MONTGOMERY COUNTY HISTORIC PRESERVATION COMMISSION
STAFF REPORT

Address:	15911 Redland Road, Derwood	Meeting Date:	9/4/2024
Resource:	Master Plan Site #22/03-003A <i>Derwood Store and Post Office</i>	Report Date:	8/28/2024
Applicant:	CLW Real Estate Group (Lawrence Smith, Agent)	Public Notice:	8/21/2024
Review:	HAWP	Tax Credit:	Yes
Permit No.:	1069299 and 1070638	Staff:	Dan Bruechert
Proposal:	Siding and Window Replacement, and Porch Rehabilitation

Figure 4: Proposed window configuration for the right (west) elevation.

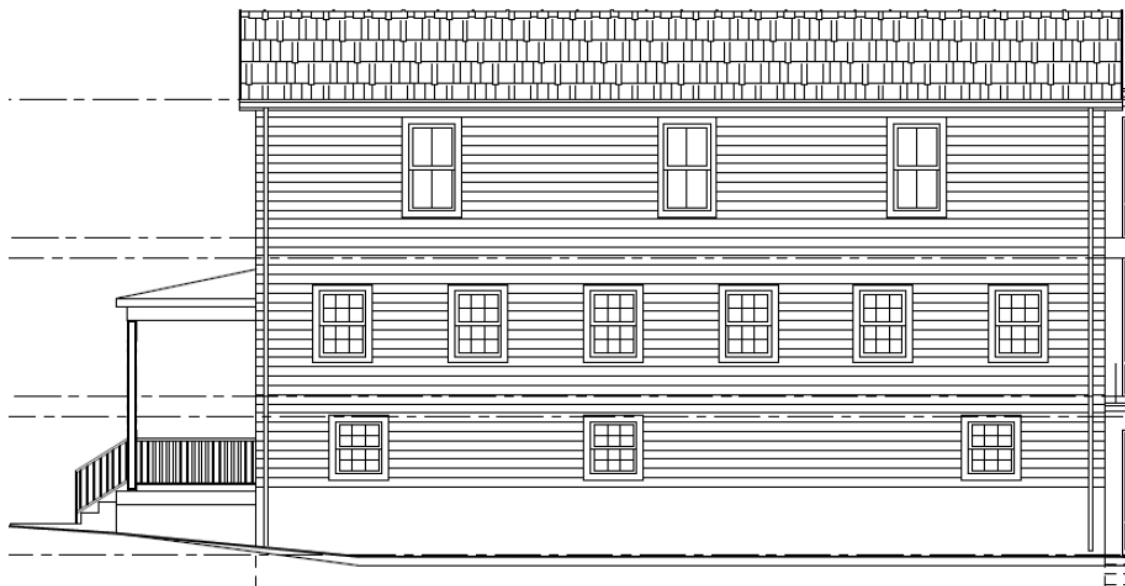
Staff finds the proposed wood windows are appropriate. Typically, individually listed Master Plan sites are required to replace damaged, deteriorated, or lost historic features with matching materials; in this case wood for wood. In most instances, the HPC has allowed simulated divided light windows, finding the visual difference is negligible. Staff concurs with this position for the modestly sized windows proposed in this HAWP and finds the SDL windows are appropriate.

Staff further finds the window configuration on the east and front elevations is consistent with the building's documented history and recommends those windows be approved under 24A-8(b)(1) and (2); and Standard 2 and 6. Staff finds the east elevation lost much of its integrity as openings were changed and relocated over the years. Additionally, the east elevation is the least visible from the public right-of-way, because the house on the left blocks much of the view. While Master Plan sites are to be evaluated in the round, the context of the site in a neighborhood factors into Staff's analysis; determining changes to the east elevation will have less visual impact on the character of the historic building. Staff finds the proposed window configuration on the east elevation is appropriate and recommends the HPC approve these windows under 24A-8(b)(2) and Standards 2. Alternatively, the HPC may determine the configuration presented at the November 2022 Preliminary consultation should be maintained, with minor modifications to accommodate the necessary basement egress.

Figure 6: Undated photo showing the Derwood Store and Post office before the porch was enclosed.

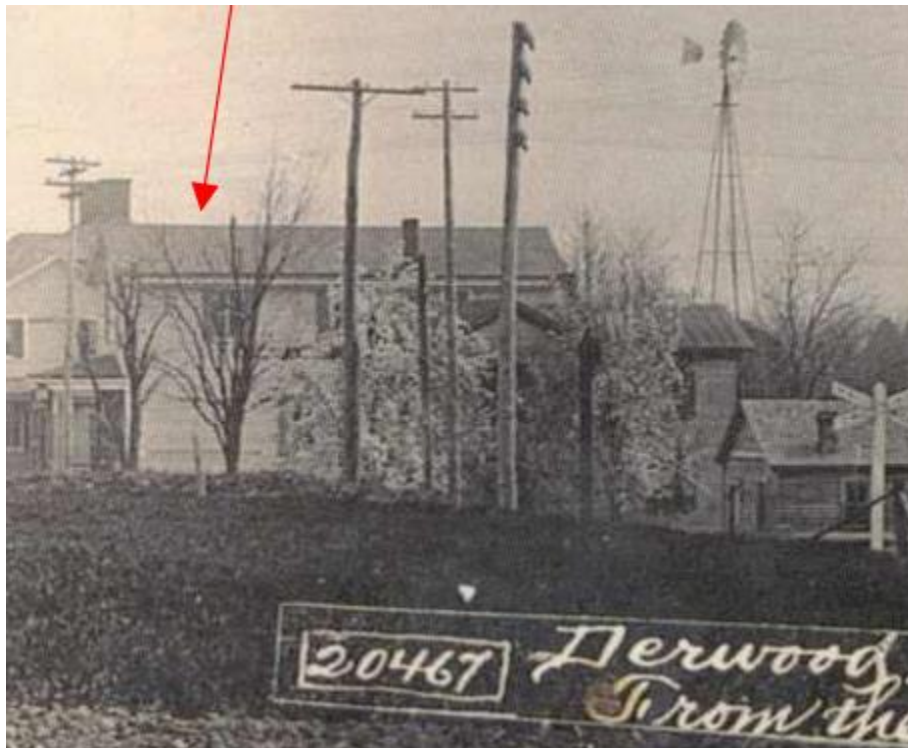
The applicant proposes to construct a porch on the existing concrete foundation, matching its footprint. The porch will be supported by 4" × 4" (four-inch square) columns and have tongue and groove wood

flooring and a balustrade constructed out of 2" × 2" (two-inch square) balusters. The hipped roof form will be maintained, with a new standing seam metal roof. The new front door will be wood and inoperable.
